Access Compliance Report

Public Rights-of-Way

(Curb Ramps)

Intersection ID: 27536	Main Street: DOWINGTON_DR	Cross Street: WOODRIVER_LN	Location: SW
ADA ID: 890CAECCF0BE	Ramp Type: Perp	Initial Pass/Fail: Fail	Overall Compliance: No
			Severity Score: 50

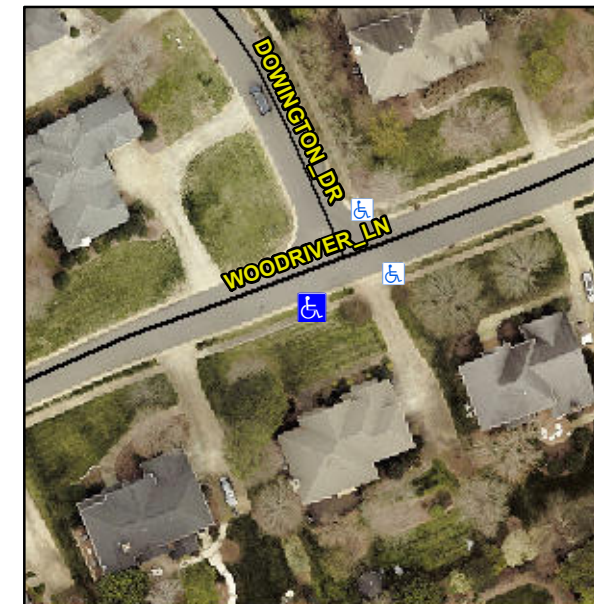
R304.2.2, R304.5.3

Compliance	Description	Data	Compliance	Description	Data
N/A	Ramp Length (in)	96.0	No	Ramp Slope (%)	12.4
Yes	Ramp Width (in)	48.0	No	Ramp XSlope (%)	8.1
N/A	Flare Type LT	N/A	N/A	Flare Type RT	N/A
N/A	Flare Slope LT (%)	N/A	N/A	Flare Slope RT (%)	N/A
N/A	Flare Traversable LT?	N/A	N/A	Flare Traversable RT?	N/A
N/A	Landing Length (in)	N/A	N/A	DWS Provided?	N/A
N/A	Landing Width (in)	N/A	N/A	DWS Contrast?	N/A
N/A	Landing Slope (%)	N/A	N/A	DWS Length (in)	N/A
N/A	Landing X Slope (%)	N/A	N/A	DWS Full Width?	N/A
N/A	Landing Curb? (Y/N)	N/A	N/A	DWS Offset (in)	N/A
N/A	Shared Landing?	N/A			
N/A	Gutter Ponding?	N/A	N/A	Gutter Slope (%)	N/A
N/A	Gutter Lip Ht (in)	N/A	N/A	Gutter X Slope (%)	N/A
N/A	Painted X Walk1?	No	N/A	Painted X Walk2?	N/A
	X Walk 1 Direction	To N		X Walk 2 Direction	N/A
N/A	X Walk 1 Width (in)	N/A	N/A	X Walk 2 Width (in)	N/A
	X Walk 1 Slope (%)	3.7		X Walk 2 Slope (%)	N/A
	X Walk 1 X Slope (%)	7.7		X Walk 2 X Slope (%)	N/A

Remove & Replace Entire Ramp.
